UNITED STATES PATENT AND TRADEMARK OFFICE

10/589,806

Office Action Summary	Application No. 10/589,806	Applicant(s) SCHUMANN, LARS	
	Examiner James English	Art Unit 3616

DETAILED ACTION

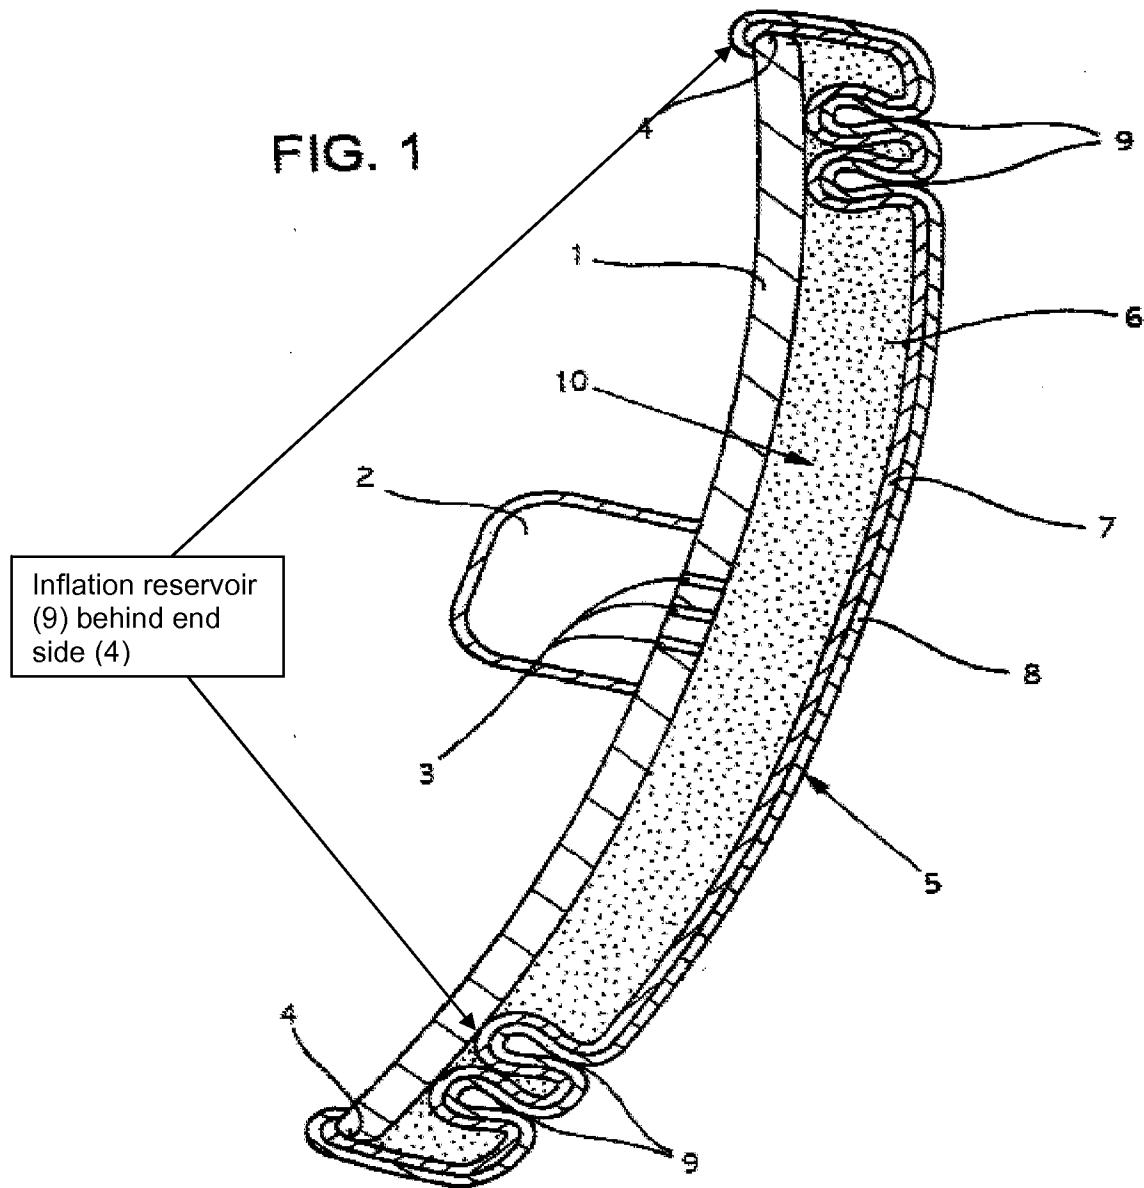
8. Claims 10-12, 14-17, 19-20, 22-23, and 28-29 are rejected under 35 U.S.C. 102(b) as being anticipated by Tietz (DE 10123207), as applicant admitted prior art.

With respect to claims 10-12 and 28-29, Tietz discloses an airbag cover (5) on an end side (4) of the basic body (1) facing the vehicle occupant (Fig. 1), bearing directly against the basic body (1) and engaging around at least one edge (4) of the end side. (Figs. 1-2.) Tietz further discloses an inflation reservoir (9) provided for the airbag cover (5), wherein the inflation reservoir (9) is arranged behind the end side (4) of the basic body (1). (Modified - Fig. 1 below.) Tietz further discloses the basic body (1), together with the inflatable airbag cushion (10 and 6), forming a separate module. (Fig. 1.) Tietz

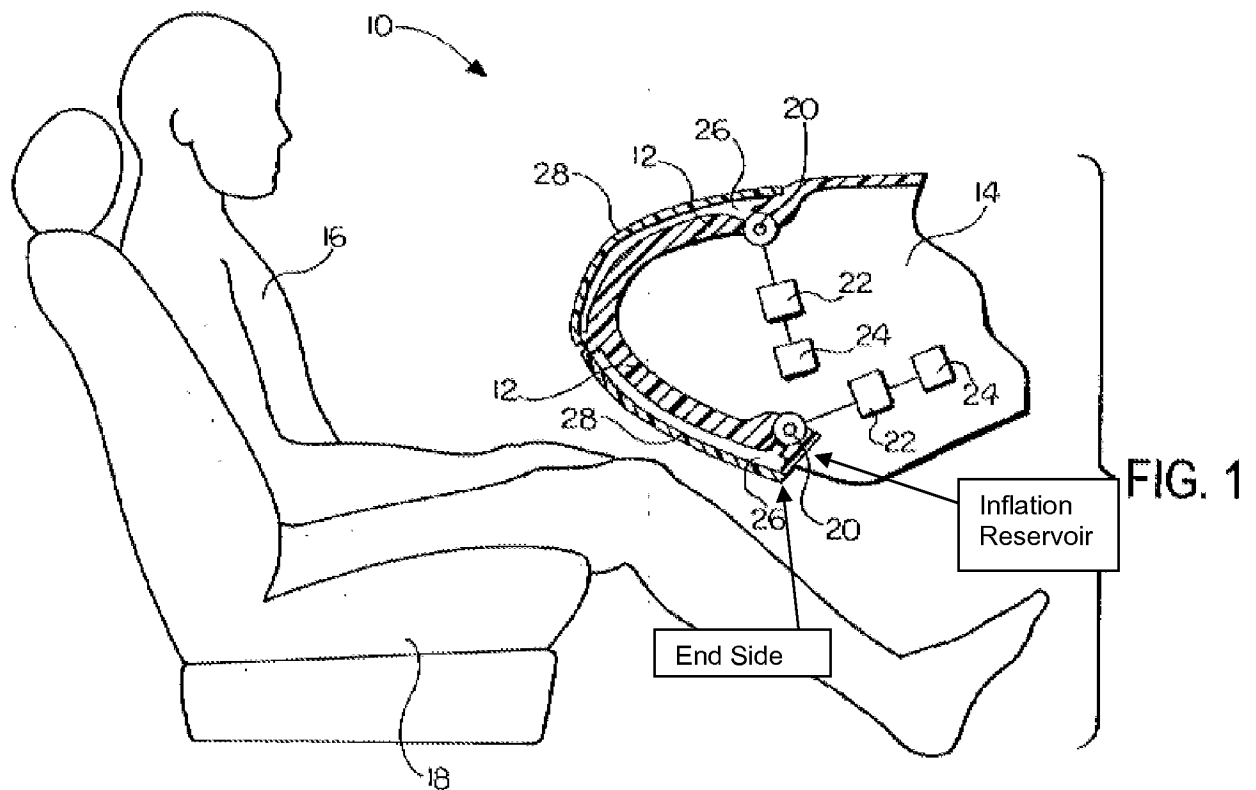
9. Claims 10-14 and 16-29 are rejected under 35 U.S.C. 102(b) as being anticipated by DePue et al. (US Pub. No. 2004/0100080 A1).

With respect to claim 10, DePue et al. discloses an airbag cover ("expandable skin" - 28) for protecting vehicle occupants against injuries during accidents, the airbag cover (28), on an end side of the basic body ("housing" - 12) facing the vehicle occupant, bearing directly against the basic body (12) and engaging around at least one edge of the end side. (Modified Fig. 1 – below.) DePue et al. further discloses an inflation reservoir for the airbag cover (28), which is arranged behind the end side of the basic body. (Modified Fig. 1 – below.)
